**Proposed Residential Development (Flat) with Shop and Services Use
and Minor Relaxation of Plot Ratio and Building Height Restrictions
at Lots 531 RP, 532 S.D. RP and 532 RP in DD 130 and
the adjoining Government Land, Lam Tei, Tuen Mun
(Planning Application No. A/TM-LTTY/502)**

- Further Information No. 6 -

Response-to-Comment Table

Figure: 2.1

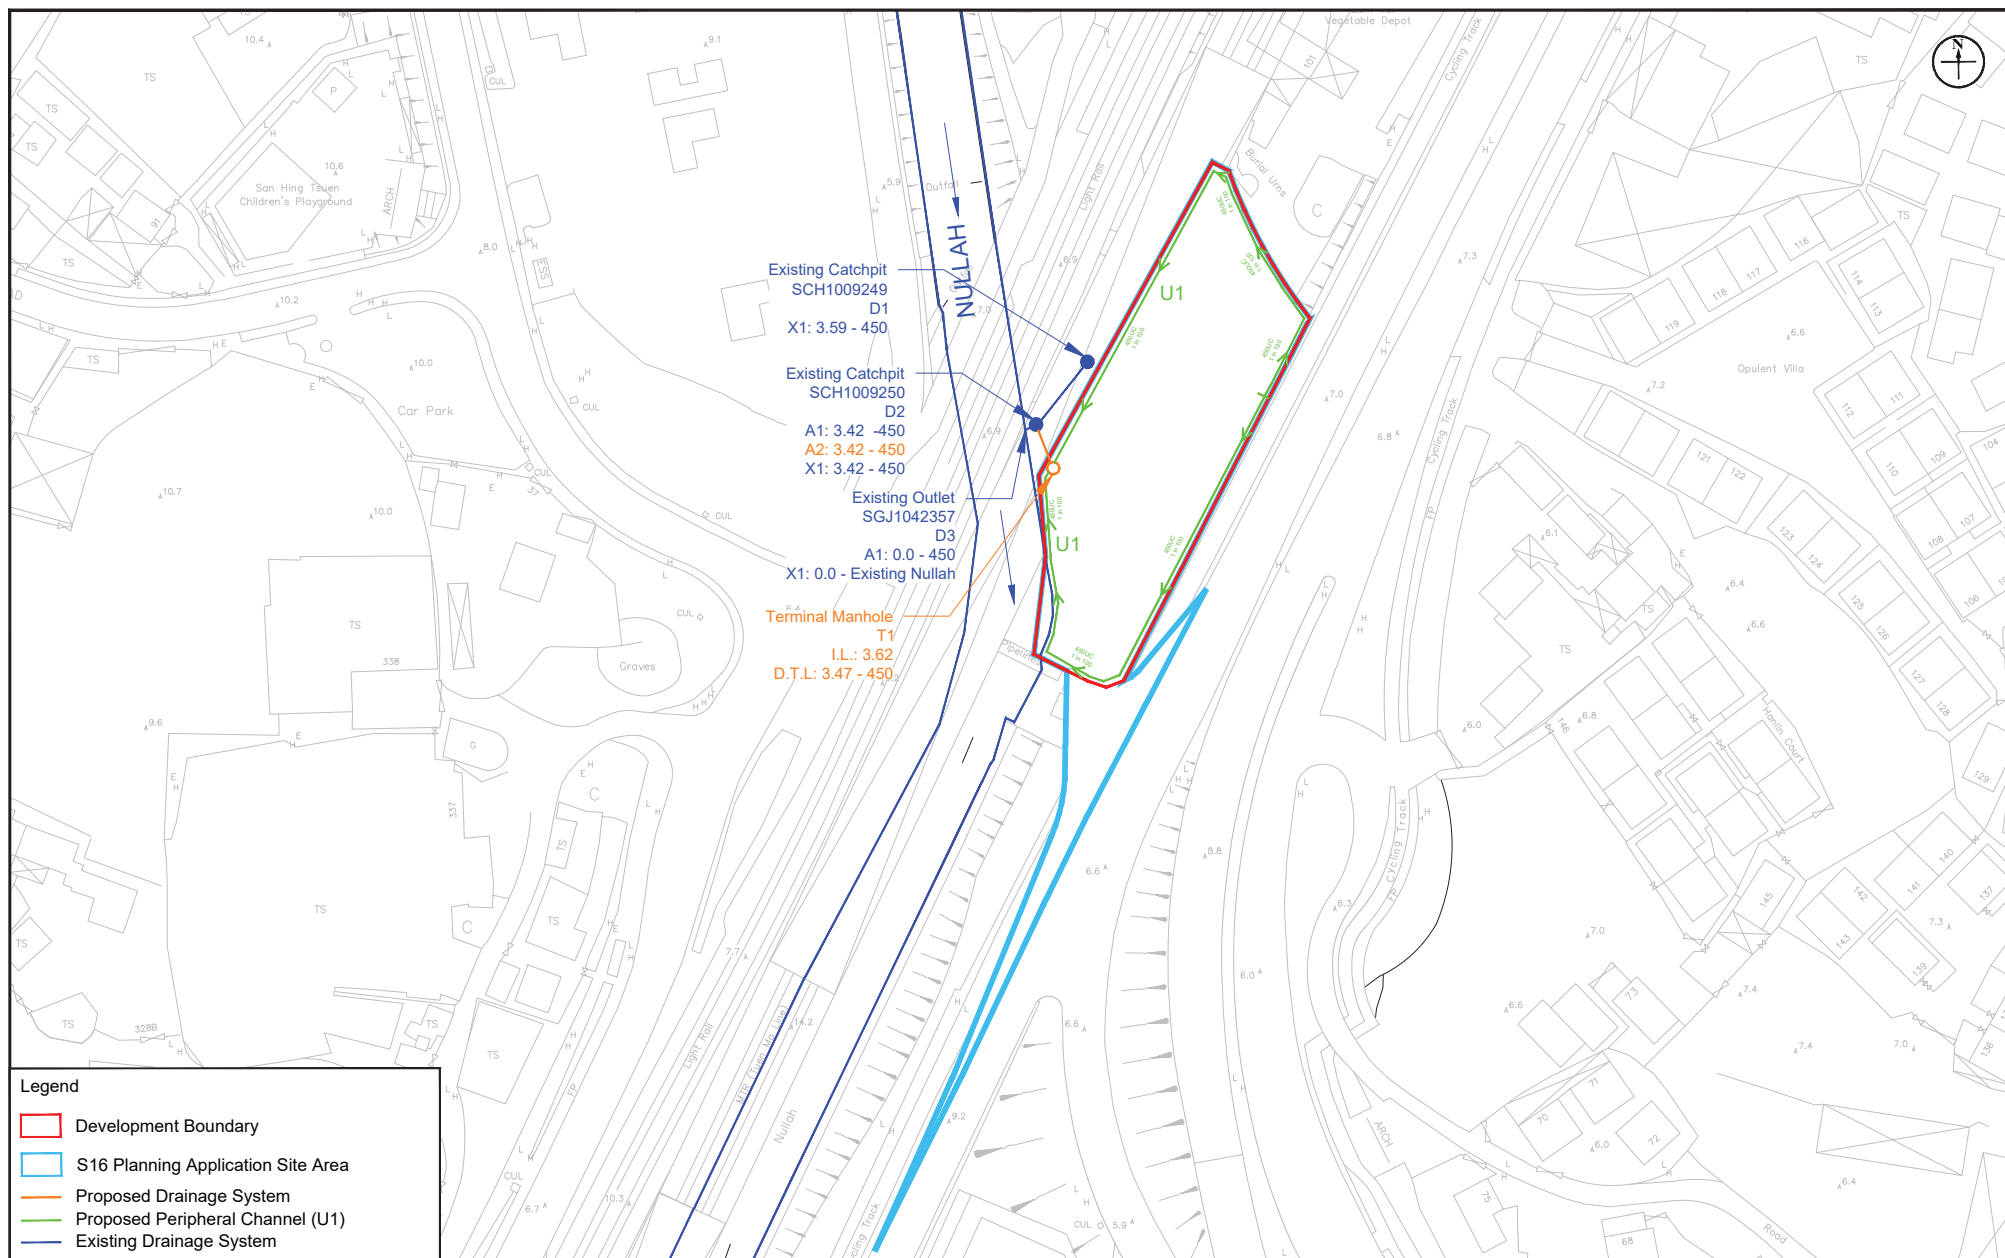
Comments	Response
<u>Comments from the Drainage Services Department</u> (Contact Person: Miss Jenny CHOW, Tel: 3965 8875) <u>Comments on DIA</u> 1. Re: Table 2.1 at Section 2.4.3, the sum of runoff from S1, STP, A1, A2 ($0.115+0.015+0.056+0.006$) does not equal to the total runoff $0.177 \text{ m}^3/\text{s}$. Please review and revise accordingly. 2. Re: Section 2.4.4, 2.5.4 and 3.1.3, further to Comment 1 above, please revise the total discharge volume of Site (i.e. $0.13 \text{ m}^3/\text{s}$) accordingly. 3. Re: Appendix 2.1 Detailed DIA Calculation, a. For Table 2b, the estimated effluent $0.018 \text{ m}^3/\text{s}$ does not tally with the content throughout the report (i.e. $0.015 \text{ m}^3/\text{s}$ in Section 2.4.4 and Section 2.5.3). Please review and revise. b. For Table 3a, the downstream manhole reference for both segments are missing. Please supplement. c. For Table 4a, the downstream manhole reference for both segments are missing. Please supplement. <u>No Comment on SIA</u>	Noted, Table 2.1 has been revised accordingly. The estimated effluent of STP is $0.015 \text{ m}^3/\text{s}$, thus the total discharge volume of the development boundary is $0.13 \text{ m}^3/\text{s}$. Therefore, no update is required for Sections 2.4.4, 2.5.4 and 3.1.3. The estimated effluent of STP is $0.015 \text{ m}^3/\text{s}$. Appendix 2.1 has been updated accordingly (Appendix I refers). Noted, relevant information has been added. Noted , relevant information has been added. Noted.

- 2.4.2 A peripheral channel will be proposed along the Site Boundary to cater the uphill catchment from the site.
- 2.4.3 **Figure 2.2** shows the catchment area related to the drainage network serving the Site. Compared with the previous version of master layout plan, the Development Boundary has been reduced. Therefore, the surrounding catchment areas and the calculation of the surface runoff have been updated. However, the calculated surface runoff would not be worse than before. The surface runoff from the Site and surrounding catchment areas have been estimated and presented in **Appendix 2.1**. The surface runoff after development is summarized below in **Table 2.1**.

- 2.4.4 The treated effluent from the proposed on-site STP of 15.2 L/s (i.e. 0.015m³/s) has been considered in this DIA. The total discharge volume of the **development boundary** (i.e. future surface runoff + effluent from proposed on-site STP) is considered to be 0.13m³/s.

- 2.5.4 Hence, the total discharge volume (i.e. future surface runoff + effluent from proposed on-site STP) of the **development boundary** after development is 0.13m³/s.
